7.6 All Other Instrumentation Systems Required for Safety

The information in this section of the reference ABWR DCD, including all subsections, tables, and figures, is incorporated by reference with the following departures and supplements.

Figure 7.6-4a Basic Configuration of a Typical Neutron Monitoring System Division

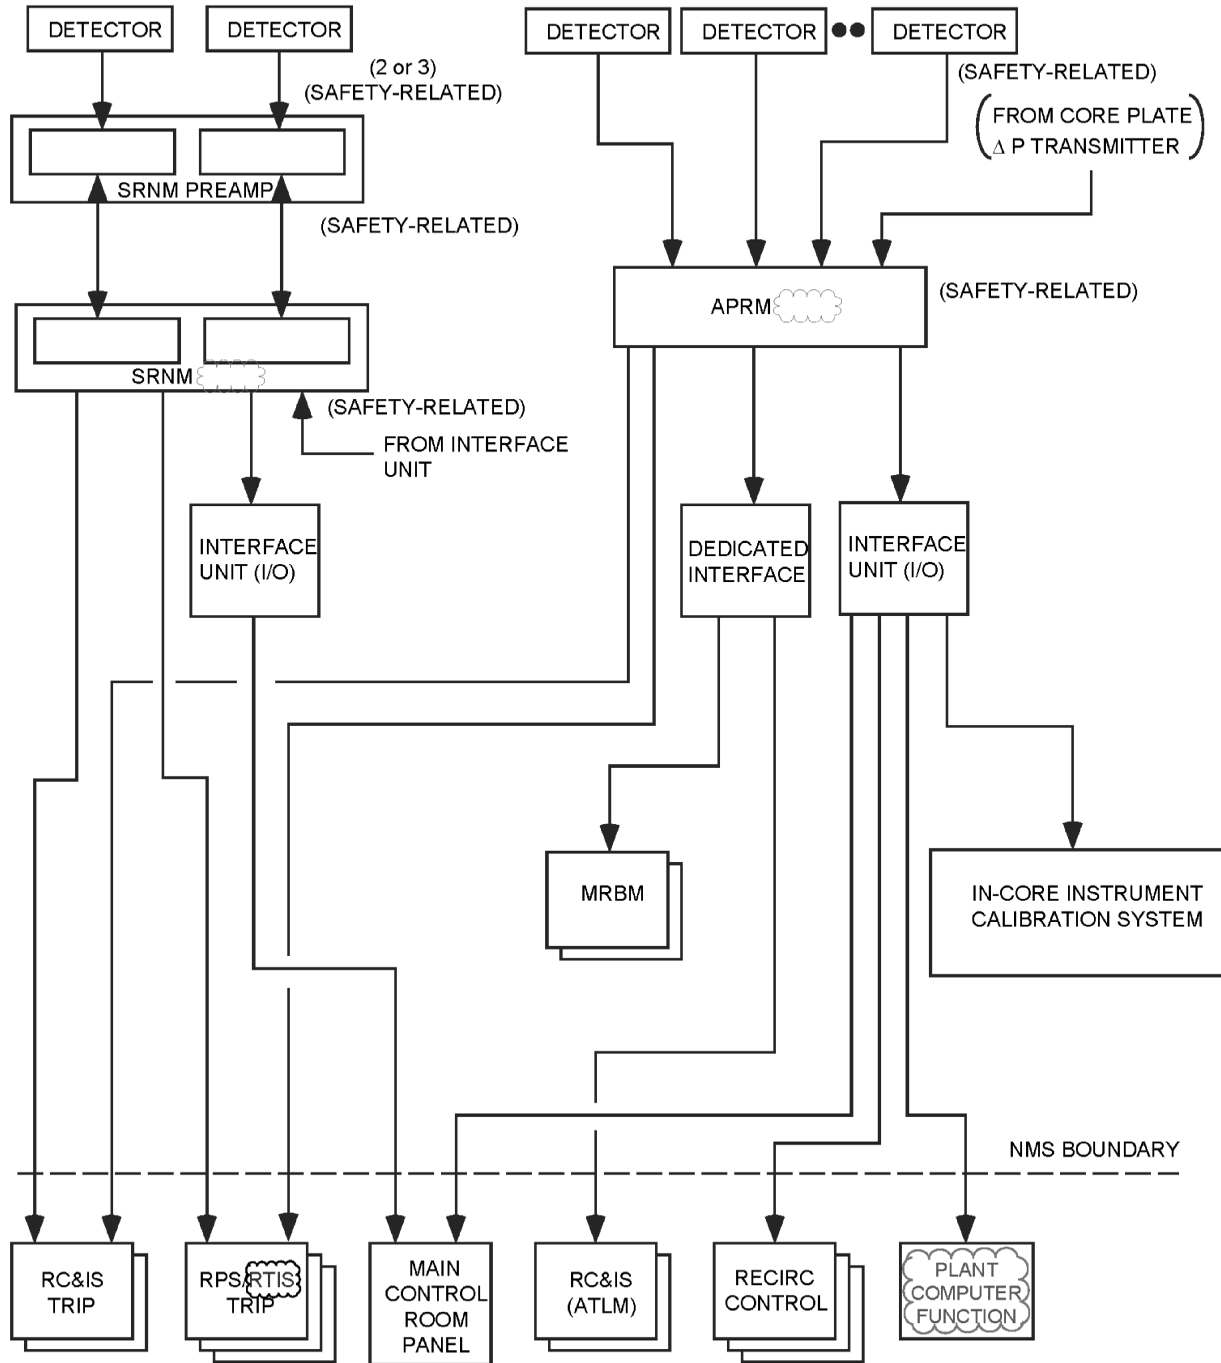
STD DEP T1 3.4-1 (Table 7.6-5 and Figures 7.6-1, 7.6-2, 7.6-4a)

The purpose of the Neutron Monitoring System (NMS) is to monitor power generation and, for the safety function part of the NMS, to provide trip signals to the Reactor Protection System (RPS) to initiate reactor scram under excessive neutron flux (and power) increase condition (high level) or neutron flux fast rising (short period) condition. The NMS also provides power information of operation and control of the reactor to the Plant Process Computer System (PCS) Functions (PCF) and the rod block monitor. A block diagram showing a typical NMS division is shown in Figure 7.6-4a. The operating ranges of the various detectors are shown in Figure 7.6-4b.

Figure 7.6-9 Instrumentation Location Definition for the Suppression Pool Temperature Monitoring System

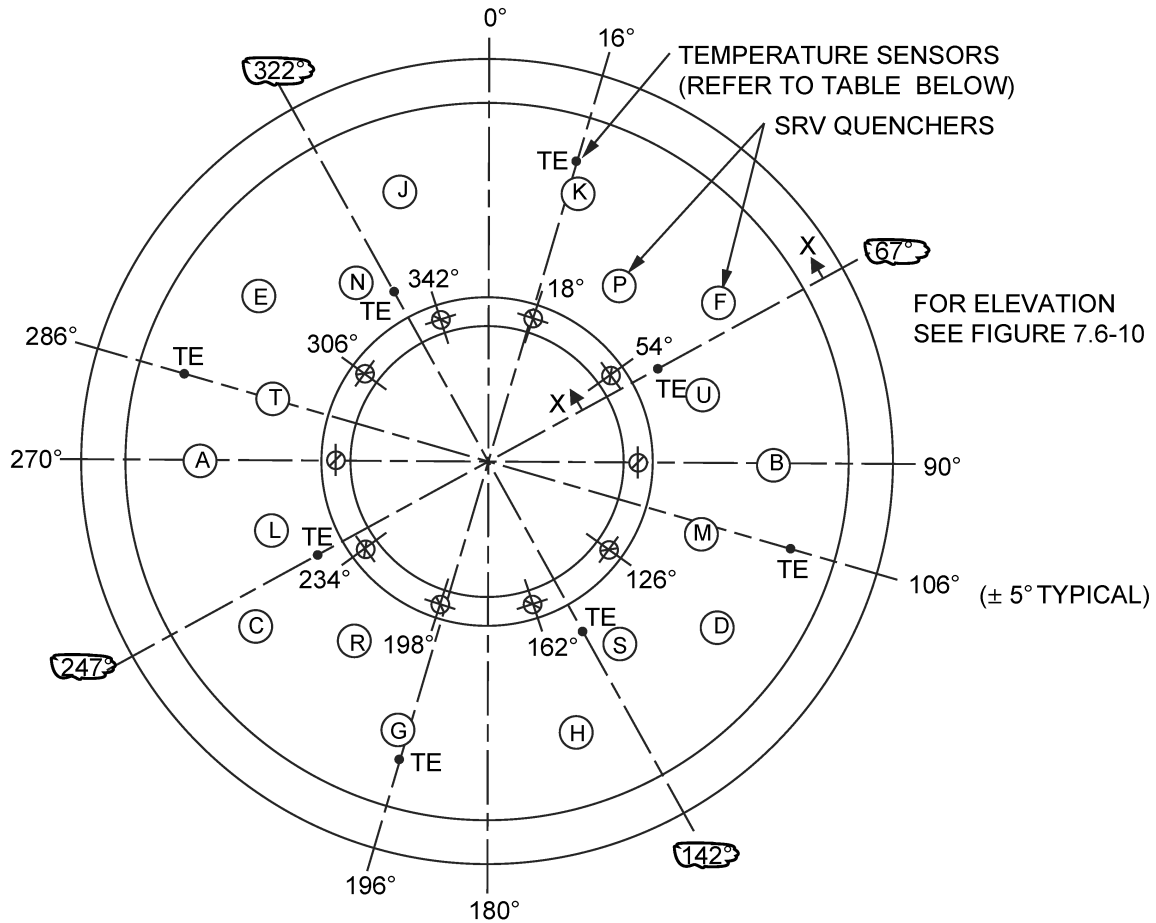
STD DEP 7.6-3 (Figures 7.6-9, 7.6-11)

The SPTM System configuration is shown in Figures 7.6-9 and 7.6-10. There are eight temperature circumferential sensor locations (Figure 7.6-9), which are chosen based upon the following considerations:

- (2) Each SRV discharge line quencher is in direct sight of two sets of temperature sensors within 9 meters.

Figure 7.6-14 OPRM Logic

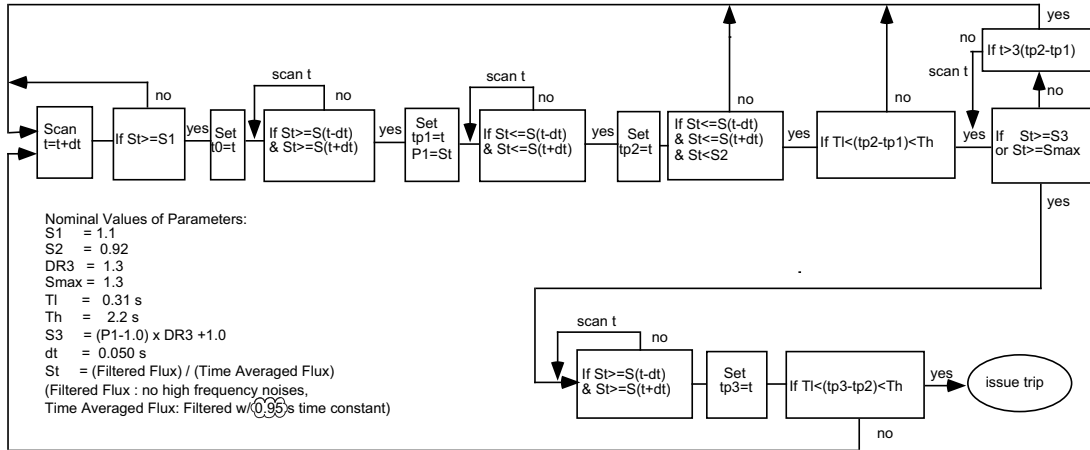
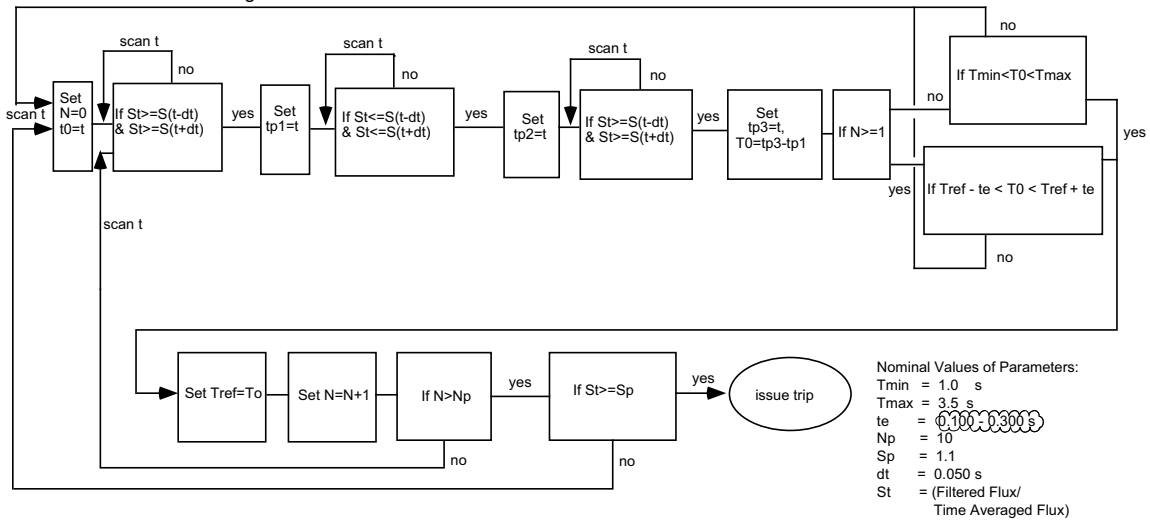
STD DEP 7.6-1 (Table 7.6-2 and Figures 7.6-2, 7.6-14)

For the OPRM trip function, the response signal of any one OPRM cell that satisfies the conditions and criteria of the trip algorithm will cause a trip of the associated OPRM channel. Figure 7.6-14 illustrates the trip algorithm logic. ~~The OPRM trip function does not have its own inoperative trip for insufficient number of total LPRM inputs in the channel. It follows the APRM's inoperative trip of insufficient number of LPRMs.~~ The OPRM function has its own inoperative trip when the channel has less than the required minimum operable cells, when there is an OPRM self-diagnostic fault, when the APRM instrument watchdog timer has timed out, or if there is a loss of power to the APRM instrument.
